Subject: FUEL DENSIFICATION

ORDER FOR MODIFICATION OF LICENSE

APPENDIX I TO AEC ORDER  
CHANGE NO. 10 TO THE TECHNICAL SPECIFICATIONS

SAFETY EVALUATION OF THE  
FUEL DENSIFICATION EFFECTS ON THE  
VERMONT YANKEE NUCLEAR POWER STATION

FIGURE 3.5.1 MAXIMUM ALLOWABLE PLANAR LHGR

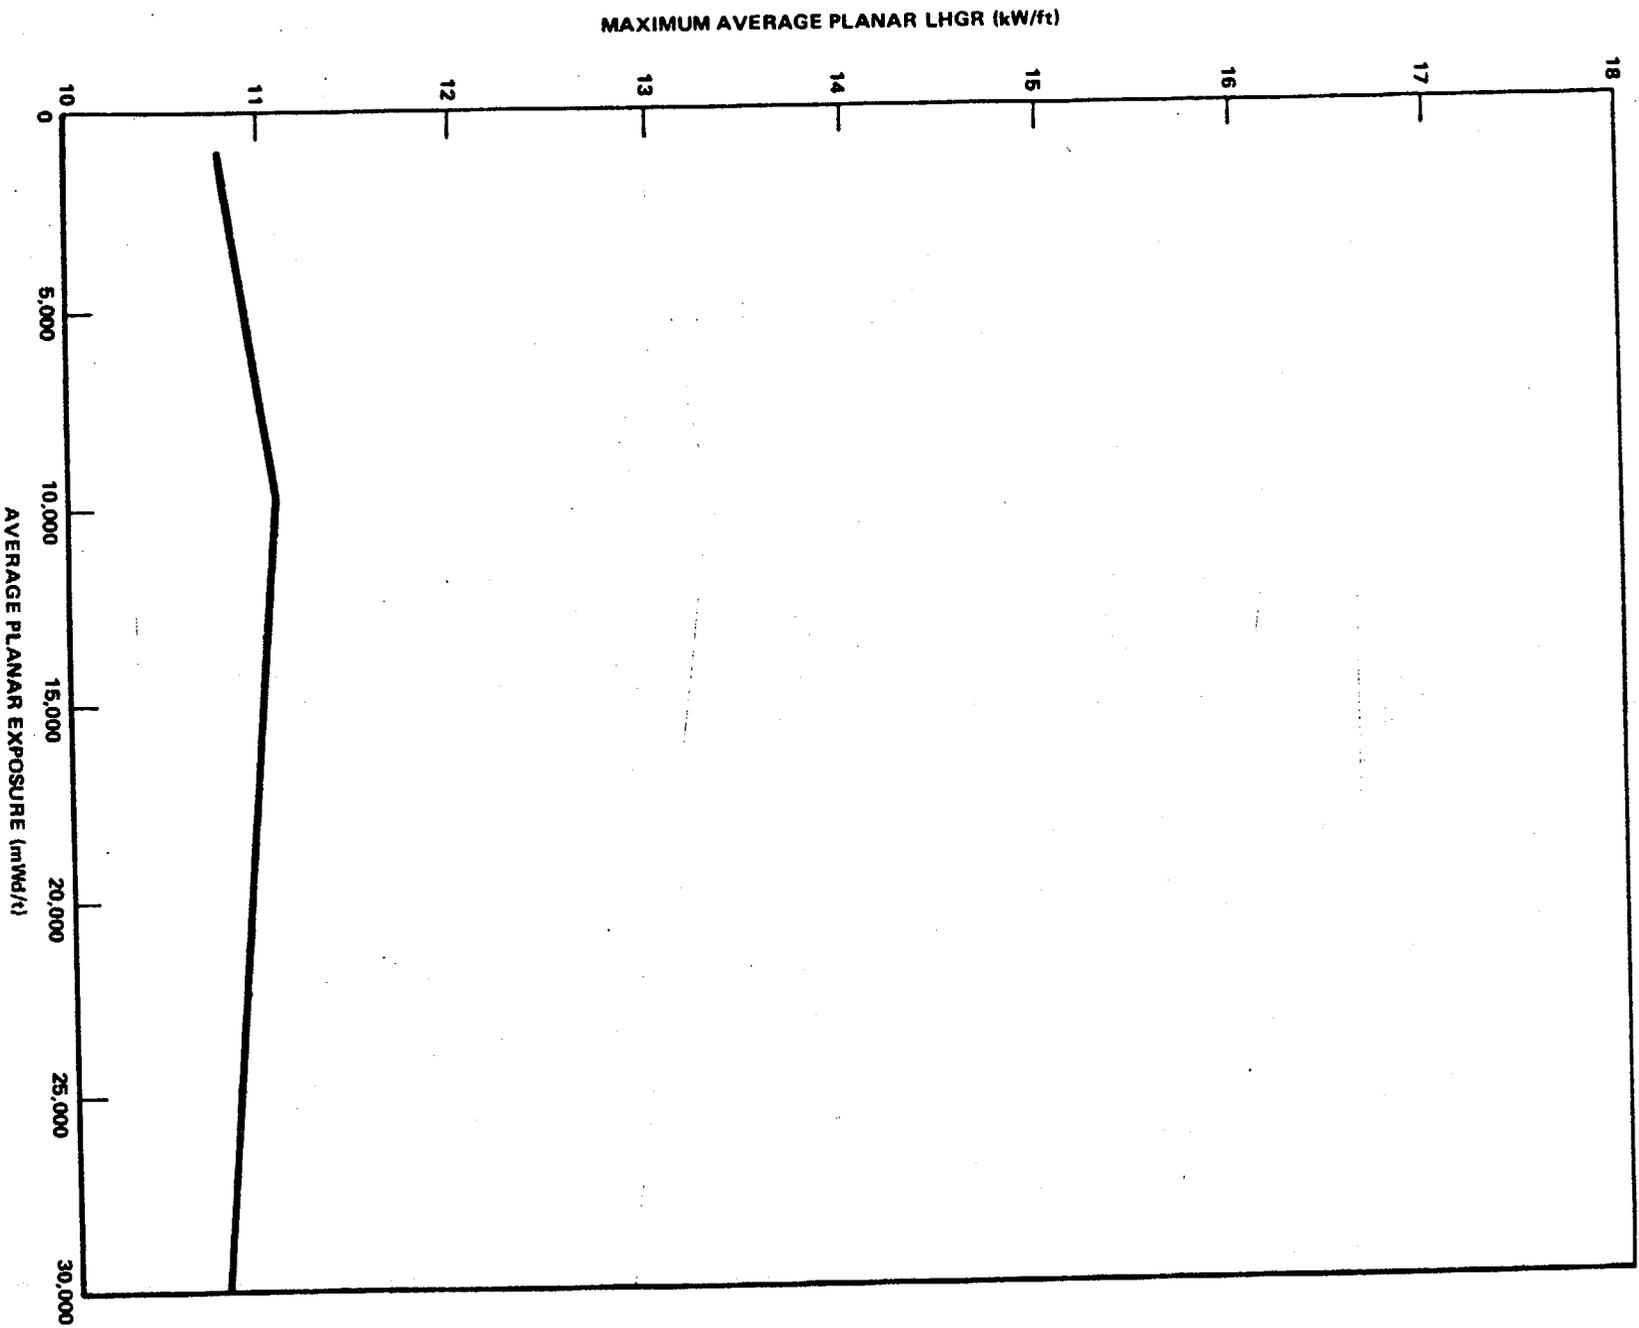
During steady state power operation, the average linear heat generation rate (LHGR) of all the rods in any fuel assembly, as a function of average planar exposure, at any axial location, shall not exceed the maximum average planar LHGR shown in Figure 3.5.1.

The maximum average planar LHGR shown in Figure 3.5.1 is the same as that shown on the curve labeled " " (gamma) on Figure 4-9G of the GE topical report "Fuel Densification Effects on General Electric Boiling Water Reactor Fuel," NEDM-10735, Supplement 6, August 1973 and is the result of the calculations presented in Section 4.3.4 of the same report. These calculations were made to determine the effect of densification on peak clad temperature and were performed in accordance with the AEC Fuel Densification Model for BWR's which is attached to NEDM-10735, Supplement 6 as Appendix B.
